ADDENDUM #1

Project Name: City of McFarland Police Department
Project Address: 402 Mast Avenue, McFarland 93250
DAI Project Number: 50184767

This Addendum is part of the bidding and contract documents and modifies the Bidding Document dated Oct 29, 2025.

L2.403

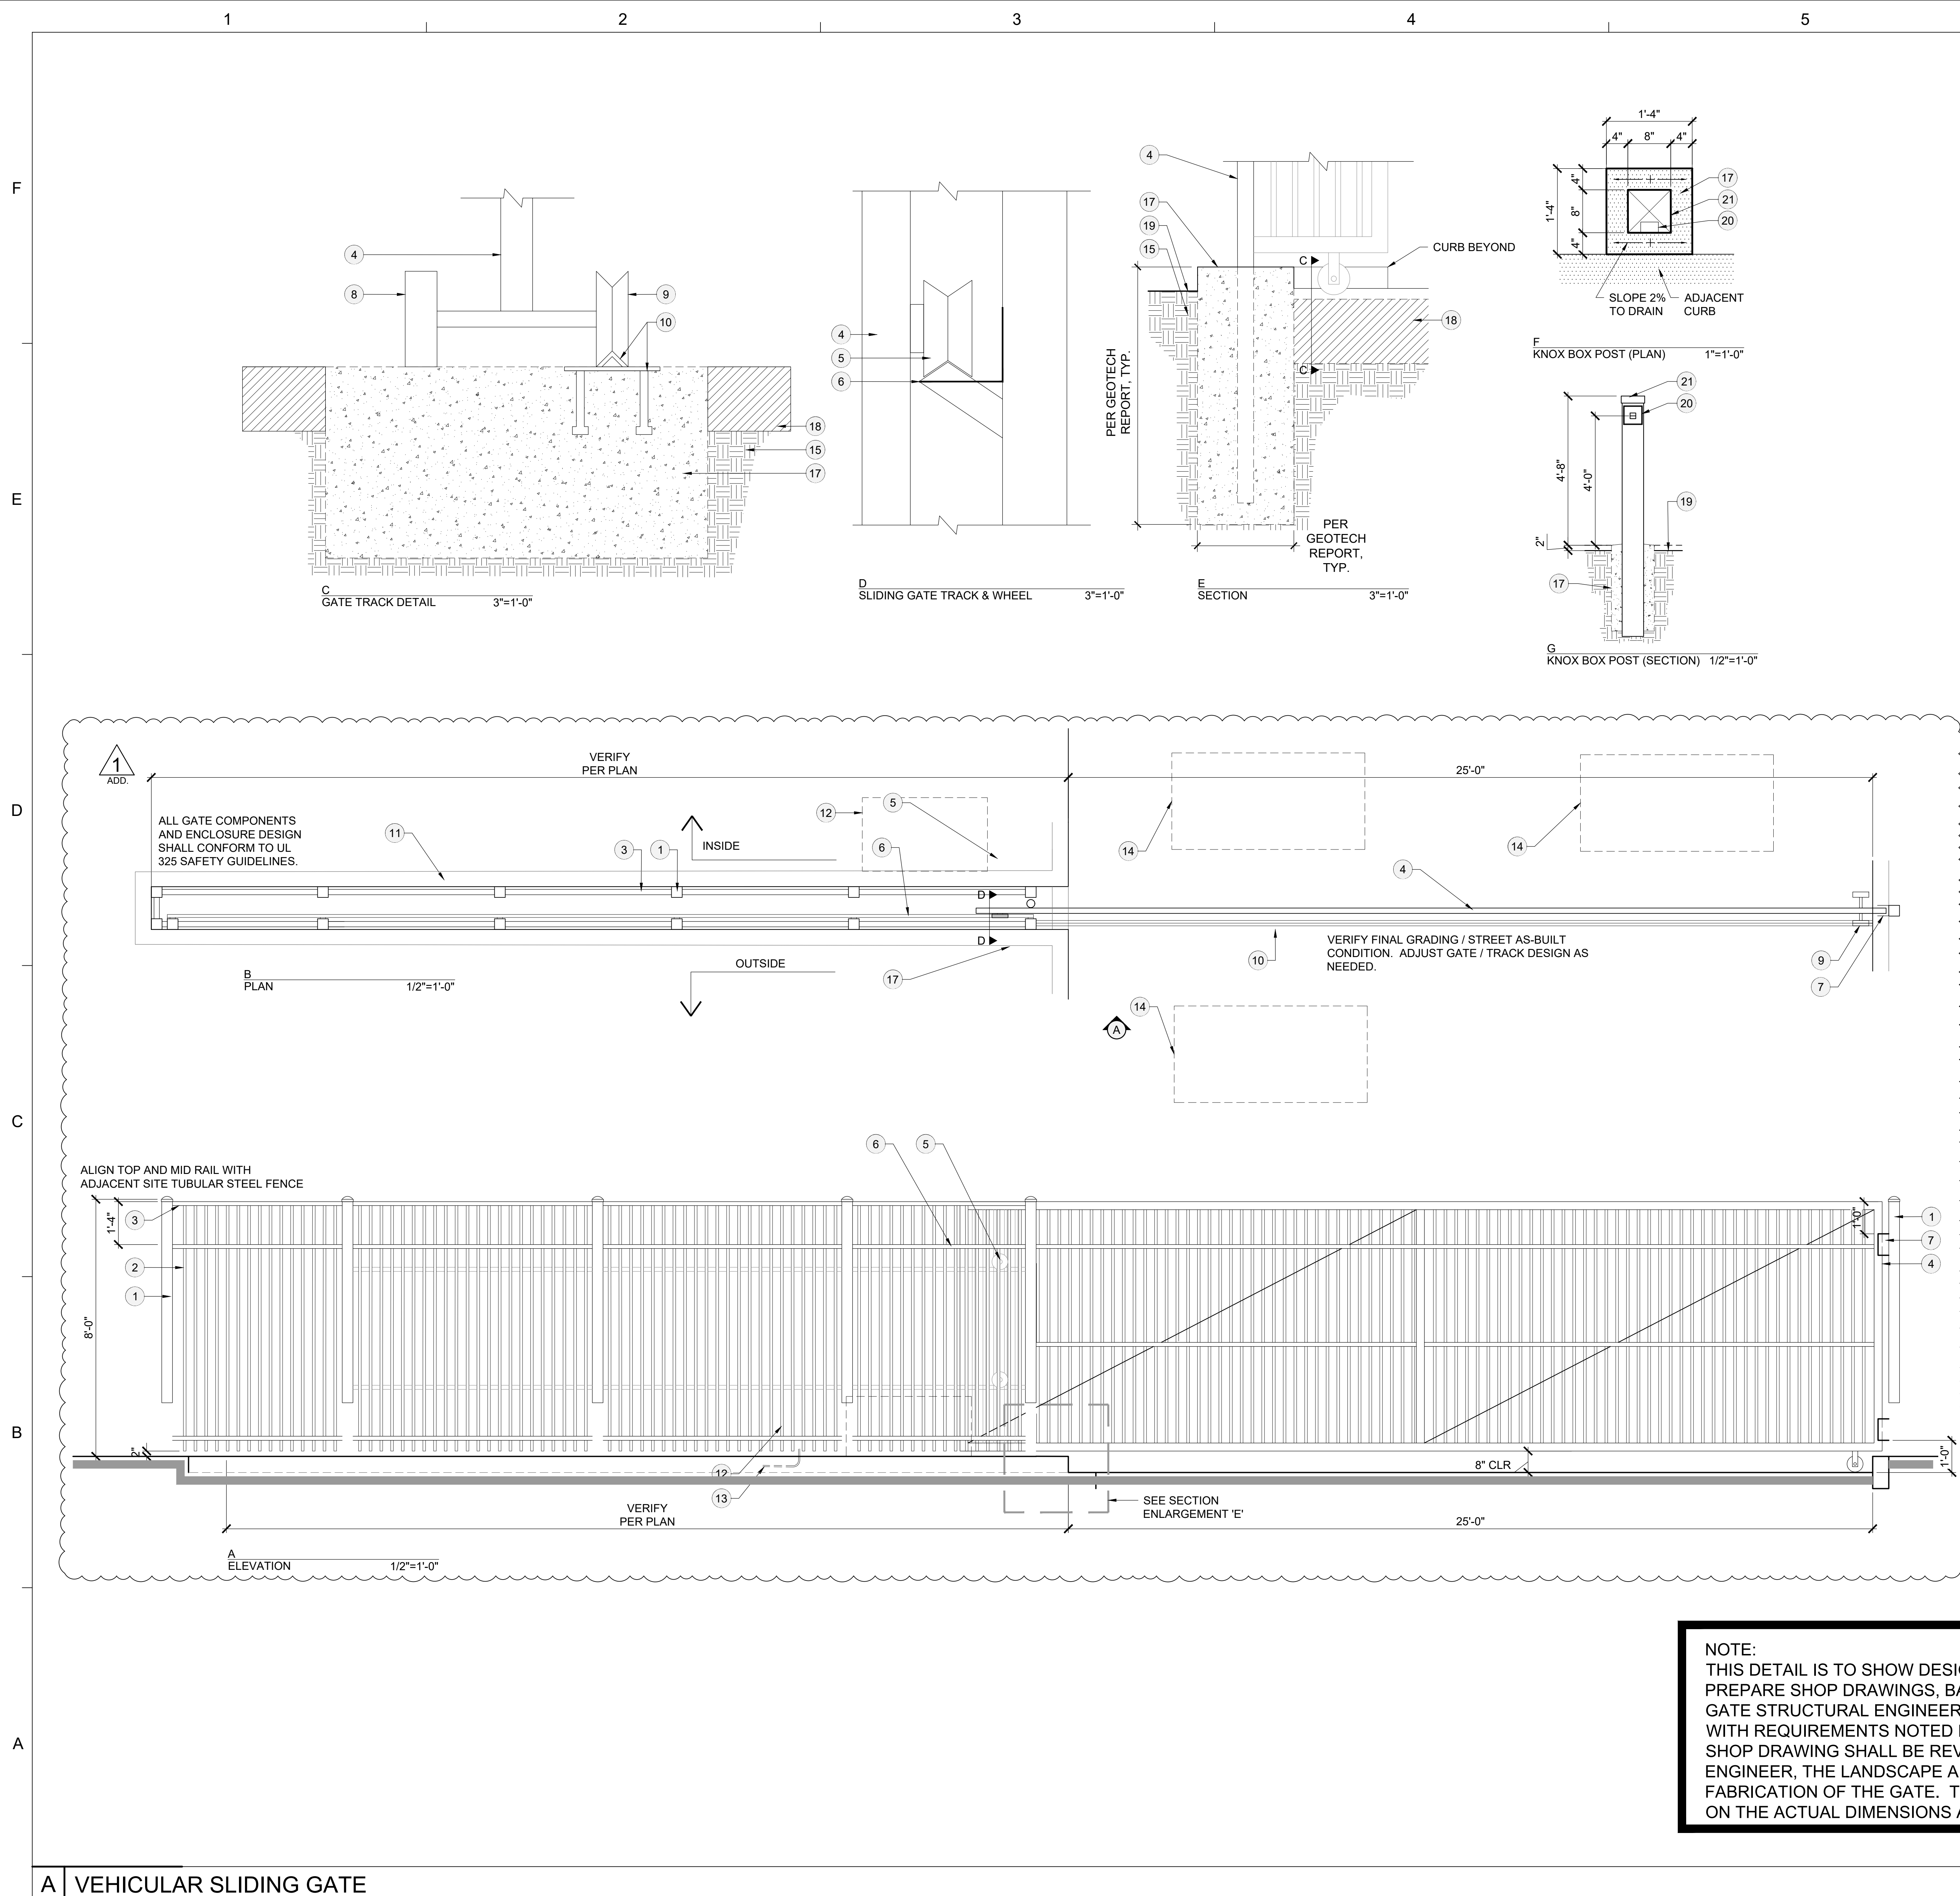
- A. Question: L2.402 shows 8' tall perimeter fence whereas L2.403 shows 6' tall sliding gate. Should the fence & gate be the same height? Which is to be used for this project? Response to RFI #1 Page 2

1. L2.001 – CONSTRUCTION LEGEND AND NOTES
 - A. Added Section F. ENTRY ACCESS CONTROL NOTES
2. L2.403 – CONSTRUCTION DETAILS
 - A. Revised A ELEVATION
 - B. Revised B PLAN
 - C. Revised LEGEND and NOTES

Response: All fences and gates are to be 8' in height, aligned with the tops aligned. Please see L2.403 in Addendum #1.
